California MLPA Master Plan Science Advisory Team
Summary of SAT Water and Sediment Quality Evaluation of Round 3
SCRSG MPA Proposals for the MLPA South Coast Study Region
(Draft revised October 7, 2009)

Overview of MPA Proposal Evaluations Regarding Water and Sediment Quality

Figure 1. Number of coastal MPAs co-located with ASBS, with Northern Channel Islands (NCI) shown separately

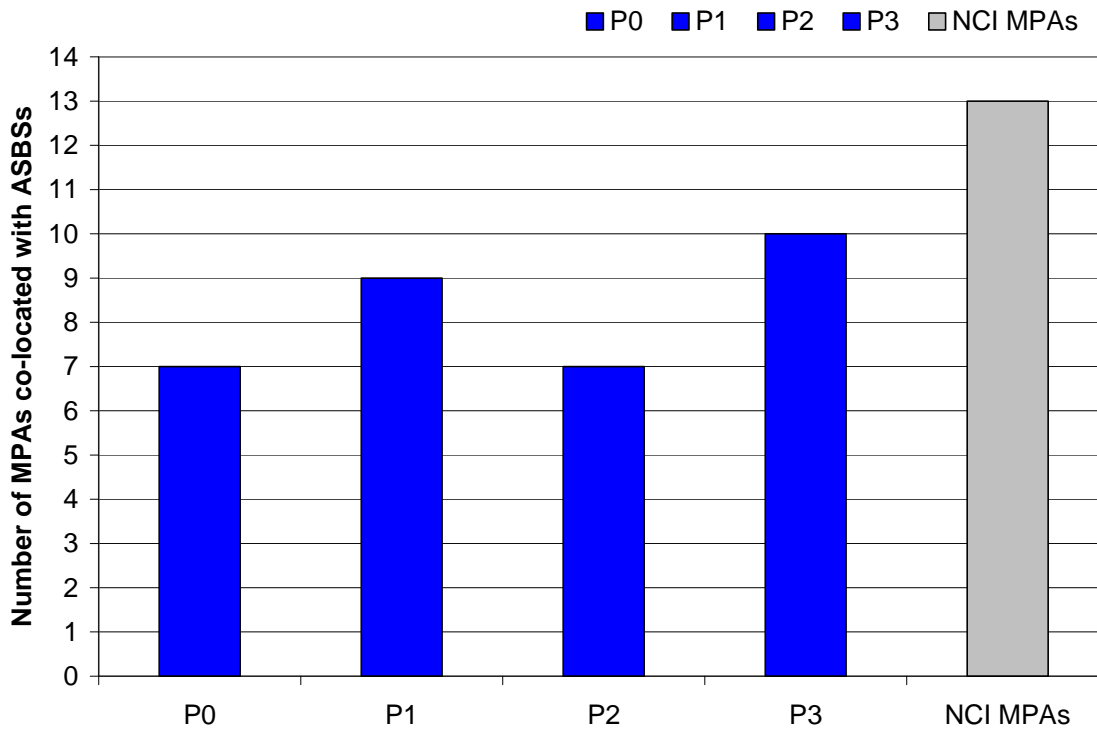
The inclusion of the 13 Northern Channel Islands (NCI) MPAs equally in all proposals helped to improve overall weighted scores due to co-location with large ASBSs at those island MPAs (Figure 1). In addition to being co-located with ASBSs, none of the NCI MPAs are co-located with areas of water-quality concern. Therefore all of the NCI MPAs receive the highest score of 1.0 (Table 1). Non-inclusive of the NCI MPAs, the various proposals included between 7 and 10 ASBSs in coastal¹ MPAs.

Figure 2. Scores for all water-quality evaluation categories in a given proposal

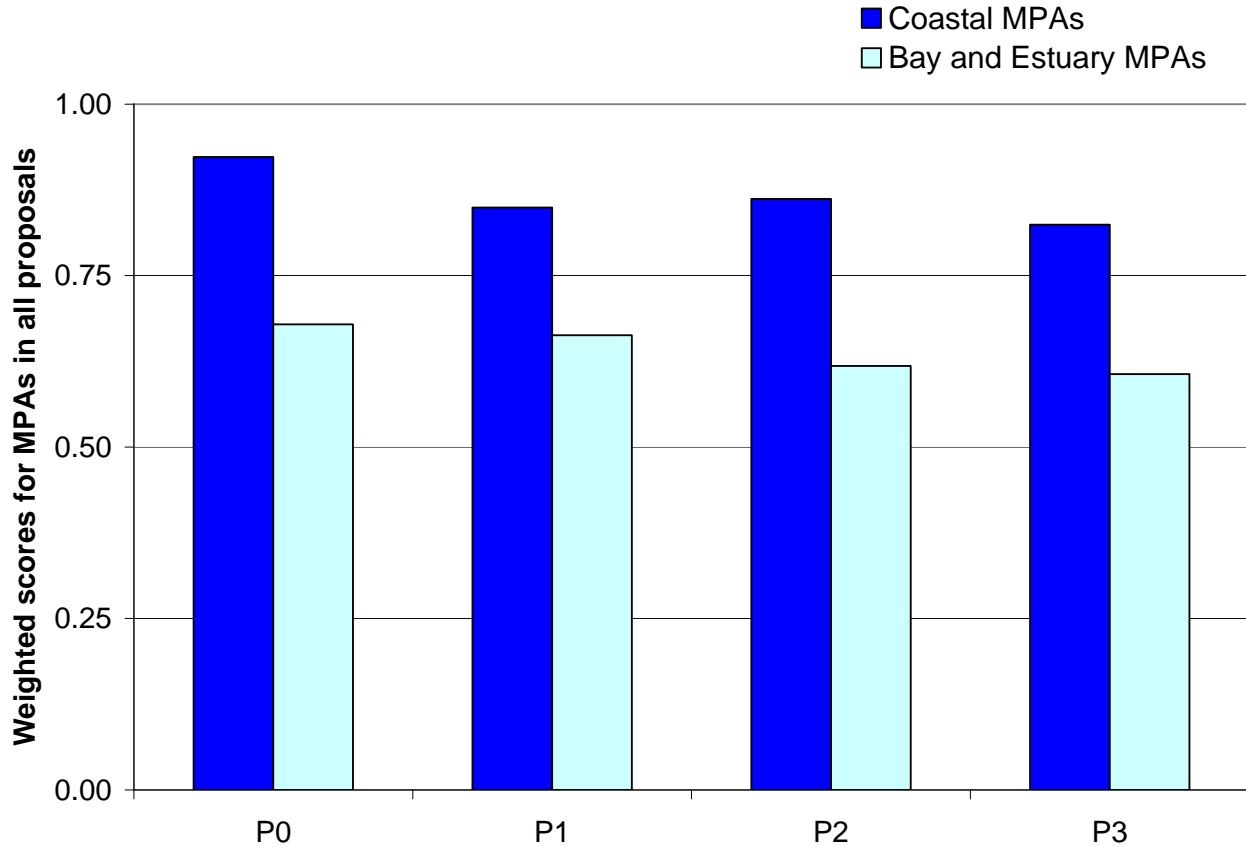
All proposals scored very well for coastal MPAs, with all proposal scores greater than 0.75 (Figure 2). The difference between the highest and lowest scores was negligible. Of the three proposals submitted for evaluation, Proposal 2 had the most favorable coastal MPAs scores followed by Proposal 1 and then Proposal 3, although the difference was very small.

Figure 3. Weighted scores and the associated water-quality concerns for all Round 2 proposals

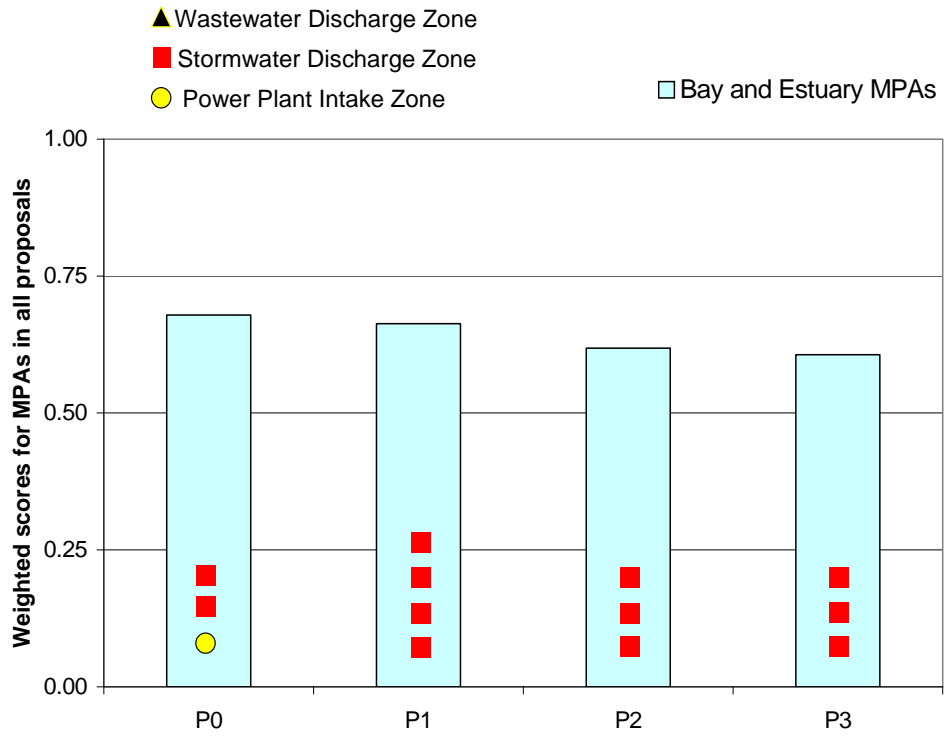
The bay and estuary MPAs scored lower than coastal MPAs for all proposals, with scores ranging from 0.61-0.66 (Figures 2 and 3). This was expected because of the reasons discussed above. All of the proposals included stormwater plumes in certain bay and estuary MPAs. Proposals 2 and 3 included the fewest major stormwater plumes in embayment MPAs, but scored lower overall than Proposal 1 because they included fewer embayment MPAs that are unaffected by stormwater plumes. It is important to state that all of the proposals did very well in excluding power plant intakes in bay and estuary MPAs. Overall, for bay and estuary MPAs, Proposal 1 had the best water-quality score, although the other two proposals also scored well. All three proposals improved on those of the previous round in avoiding water-quality concerns within bays and estuaries.

Figure 4. Proposal 0: scores for coastal MPAs with water-quality concerns

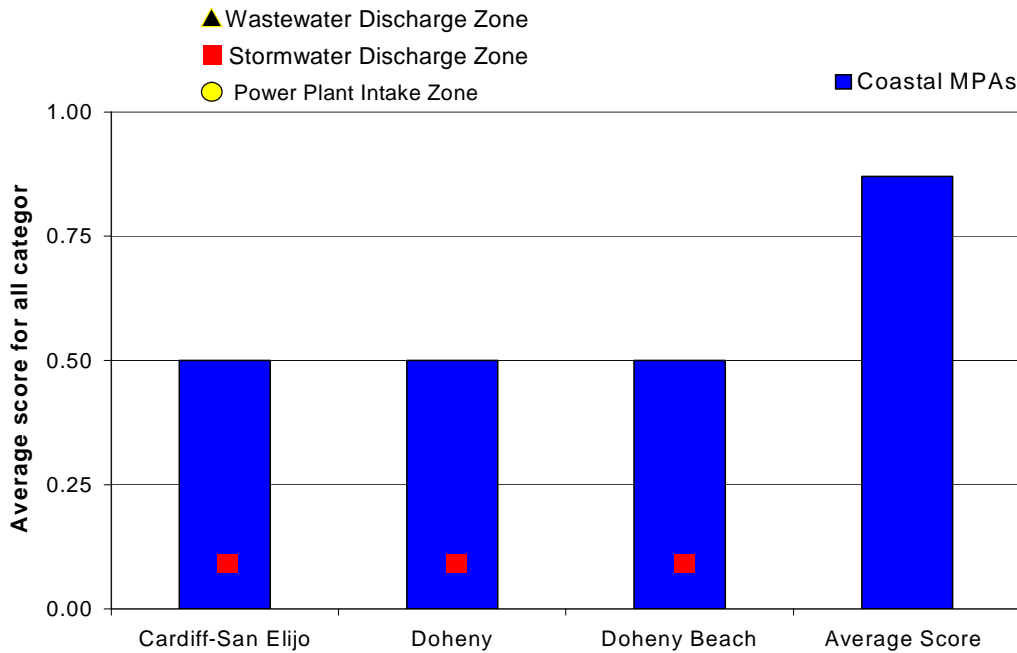
Of the existing MPAs in bays and estuaries, 57% (four of seven) scored well (0.75). There is one existing MPA co-located in a bay with a power plant intake (Encina Power Plant at Agua Hedionda Lagoon) and two located in lagoons connected to major stormwater discharge zones: San Elijo Lagoon at Escondido Creek and San Dieguito Lagoon at San Dieguito Creek.

The average score for existing coastal MPAs is 0.87. Excluding the NCI, 19 out of 22 coastal MPAs (86%) scored 0.75 or higher. Also excluding the NCI, seven of 22 (32%) existing MPAs are co-located within ASBSs (Table 2). Only three out of 22 coastal MPAs scored lower than 0.75 (located within stormwater discharge plumes at San Juan and Escondido Creeks) (Figure 4).

Figure 5. Proposal 1: Scores for coastal MPAs with water-quality concerns

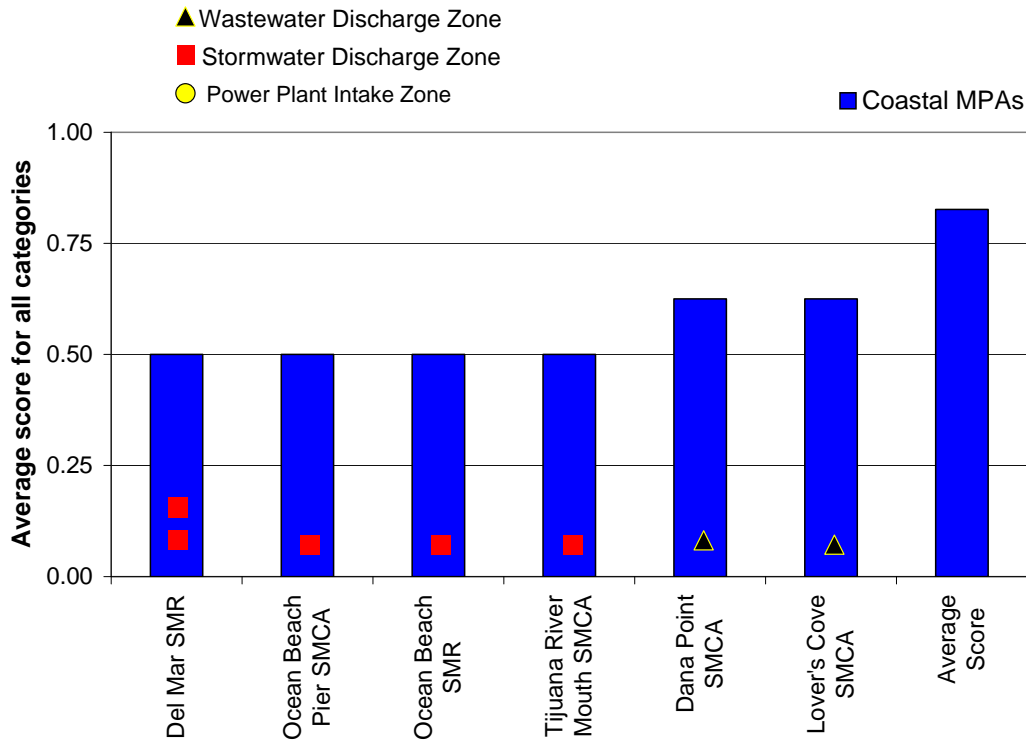
Exactly 60% of the Proposal 1 MPAs located in bays and estuaries scored well (0.75); four out of ten MPAs located in bays and estuaries scored lower than 0.75. These four MPAs were co-located with major stormwater discharge zones as follows: Los Peñasquitos Marsh SMR (Los Peñasquitos Creek), San Dieguito Lagoon SMR (San Dieguito Creek), San Elijo Lagoon SMR (Escondido Creek), and Formosa Slough SMR (San Diego River). This proposal avoided all the power plant intake zones found within bay and estuaries.

The average score for Proposal 1 coastal MPAs is 0.83 (Figure 5). Excluding the NCI, 23 out of 29 (79%) coastal MPAs scored 0.75 or higher. Excluding the NCI, 9 of 29 (31%) coastal MPAs are co-located within ASBSs (Table 3). There were six coastal MPAs that scored lower than 0.75. Four coastal MPAs (Del Mar SMR, Ocean Beach Pier SMCA, Ocean Beach SMR, and Tijuana River Mouth SMCA) received reduced scores because they were located within major stormwater discharge zones (San Dieguito and Peñasquitos Creeks, San Diego River, and Tijuana River respectively). Del Mar SMR was located within two stormwater discharge zones; the San Dieguito and Peñasquitos Creeks can be found on either side of this MPA. Two coastal MPAs (Lover’s Cove SMCA and Dana Point SMCA) received reduced scores because

each intersected an intermediate wastewater outfall's quarter-mile buffer zone (Avalon outfall and Aliso Creek outfall, respectively). It is important to note that these two MPAs did not contain the entire outfall but slightly intersected the outer edge of the outfall's buffer zone.

Figure 6. Proposal 2. Scores for coastal MPAs with water-quality concerns and the proposal's average score

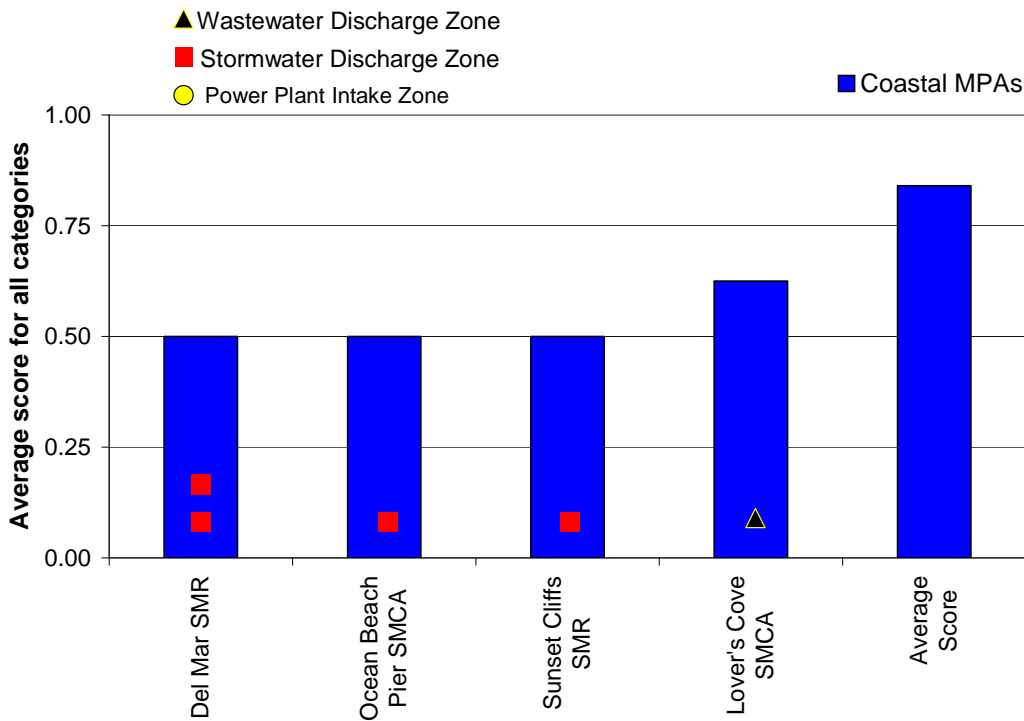
Only 50% of the Proposal 2 MPAs located in bays and estuaries scored well (0.75); three out of six MPAs located in bays and estuaries scored lower than 0.75. All of these lower-scoring MPAs were co-located with major stormwater discharge zones as follows: Point Mugu SMRMA with Calleguas Creek, San Dieguito Lagoon SMR with San Dieguito Creek, and Formosa Slough SMR with the San Diego River. This proposal avoided all the power plant intake zones found within bays and estuaries.

The average score for Proposal 2 coastal MPAs is 0.84 (Figure 6). Excluding the NCI, 17 out of 21 (81%) coastal MPAs scored 0.75 or higher. Excluding the NCI, 7 of 21 (33%) coastal MPAs are co-located within ASBSs (Table 3). There were four coastal MPAs that scored lower than 0.75. Three coastal MPAs (Del Mar SMR, Ocean Beach SMCA, and Sunset Cliffs SMR)

received reduced scores because they were located within major stormwater discharge zones (San Dieguito and Peñasquitos Creeks and San Diego River). One coastal MPA (Lover's Cove SMCA) is co-located with a wastewater discharge zone (Avalon outfall). This MPA slightly touches the outfall's quarter-mile buffer zone.

Figure 7. Proposal 3. Scores for coastal MPAs with water-quality concerns

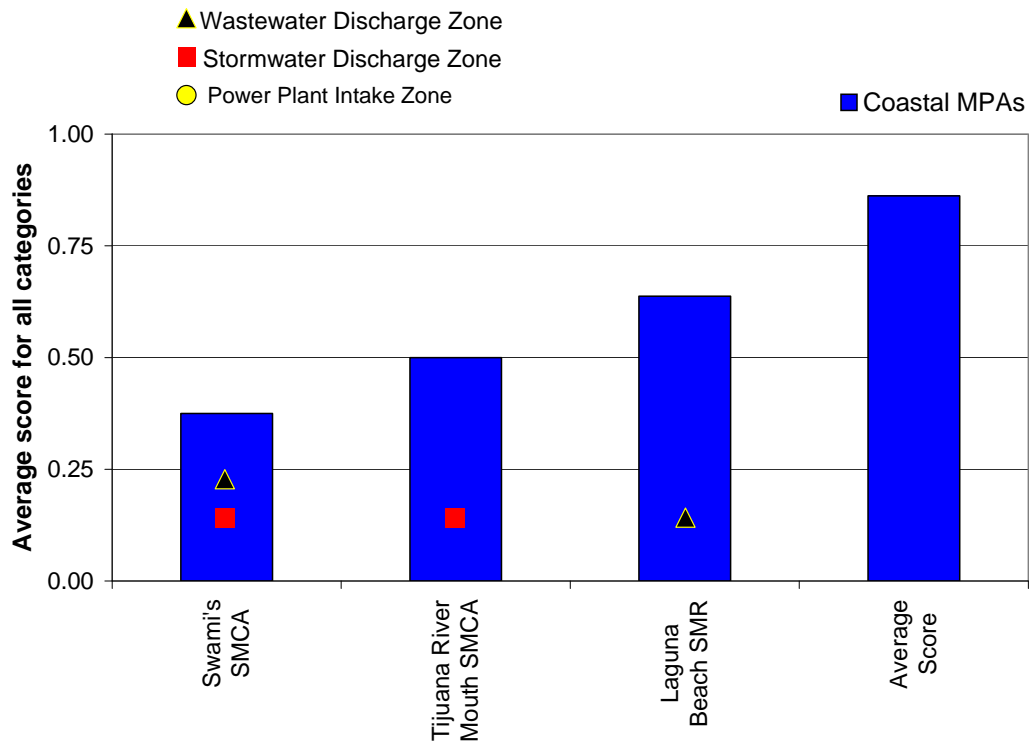
Nearly 57% of the Proposal 3 MPAs located in bays and estuaries scored well (0.75); three out of seven MPAs located in bays and estuaries scored lower than 0.75. All of these MPAs with reduced scores were co-located with major stormwater discharge zones as follows: Mugu Lagoon SMRMA with Calleguas Creek, San Elijo Lagoon SMR with Escondido Creek, and San Dieguito Lagoon SMR with San Dieguito Creek. This proposal avoided all the power plant intake zones found within bays and estuaries.

The average score for Proposal 3 coastal MPAs is 0.86 (Figure 7). Excluding the NCI, 20 out of 23 (87%) coastal MPAs scored 0.75 or higher. Excluding the NCI, 10 of 23 (43%) coastal MPAs are co-located within ASBSs (Table 3). There were three coastal MPAs that scored lower than 0.75. Two coastal MPAs (Swami's SMCA and Tijuana River Mouth SMCA) received reduced scores because they were located within major stormwater discharge zones (Escondido Creek and Tijuana River). Swami's SMCA is also co-located with a wastewater discharge zone (San Elijo outfall), while Laguna Beach SMR has a wastewater discharge zone completely contained within it (Aliso Creek outfall).
